### D.6.2.4

#### Proposed Revision to ACI 318-02 Appendix D:

Fig. RD.6.2.4 - Shear in narrow ( $c_{2,max} < 1.5c_1$ ), thin ( $h < 1.5c_1$ ) members

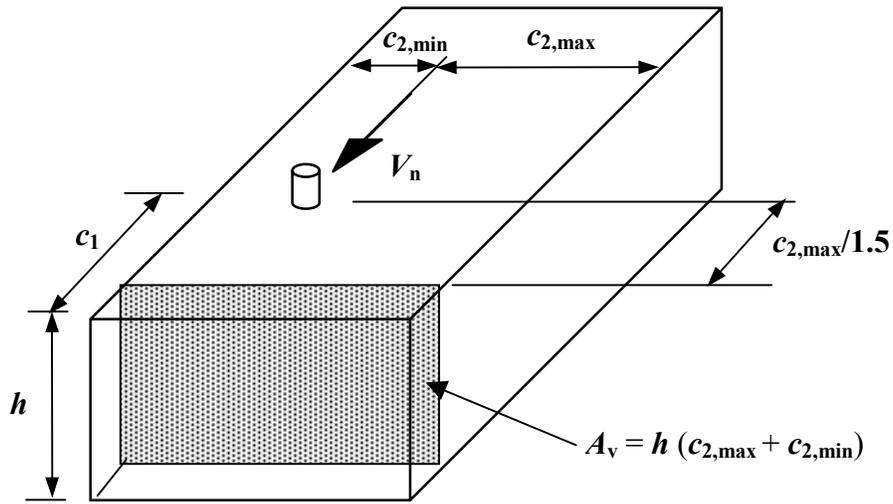
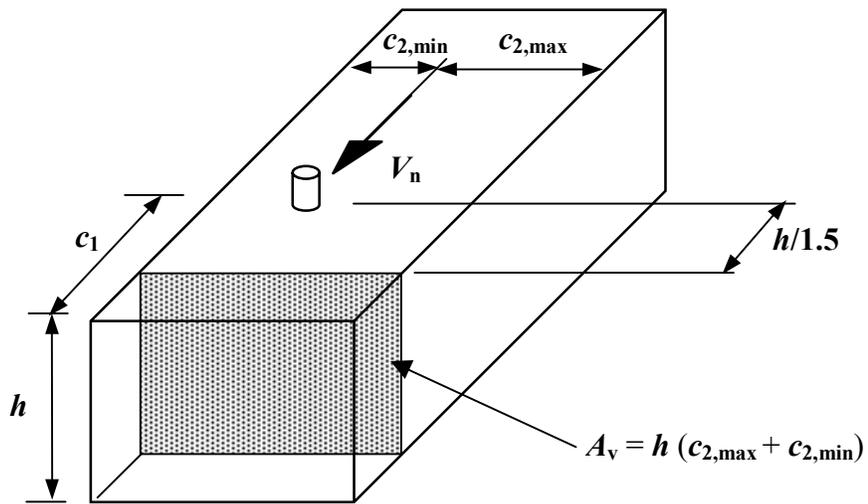
Section D.6.2.4 of ACI 318-02 deals with a very unusual condition where the shear is directed toward a free edge but there are two other close edges perpendicular to the applied load and the member thickness is less than 1.5 times the edge distance that the shear is directed toward. Although an infrequent occurrence, the current wording of D.6.2.4 has caused concern and rightly so. There was a change back in 1997 that dropped a term from this section unintentionally. The 1997 CB 30 wording, the proposed revision to D.6.2.4, and a possible new figure are provided below.

**RD.6.2.4** – For anchors in a narrow ( $c_{2,max} < 1.5c_1$ ), thin ( $h < 1.5c_1$ ) member influenced by three or more edges where any edge distance is less than  $1.5e_1$ , the shear breakout strength computed by the basic CCD Method, which is the basis for Eq. (D-23) and (D-24), gives safe but misleading results. These special cases were studied for the  $\kappa$  Method<sup>D.14</sup> and the problem was pointed out by Lutz<sup>D.20</sup>. Similar to the approach used for tensile breakouts in D.5.2.3, a correct evaluation of the capacity is determined if the value of  $c_1$  to be used in Eq. (D-22) to (D-27) is limited to  $c_{2,max}/1.5$  if  $c_{2,max} > h$  or  $h/1.5$  if  $c_{2,max} < h$ . This is shown in Fig. RD.6.2.4.

**D.6.2.4** - For the special case of anchors in a narrow ( $c_{2,max} < 1.5c_1$ ), thin ( $h < 1.5c_1$ ) member influenced by three or more edges, the edge distance  $c_1$  used in Eq. (D-22), (D-23), (D-24), (D-25), (D-26) and (D-27) shall be limited to  $c_{2,max}/1.5$  if  $c_{2,max} > h$  or  $h/1.5$  if  $c_{2,max} < h$ .

$c_{2,max} > h$  : Use  $c_{2,max} / 1.5$  for  $c_1$  in Eq. (D-22) to (D-27)

$c_{2,max} < h$  : Use  $h/1.5$  for  $c_1$  in Eq. (D-22) to (D-27)
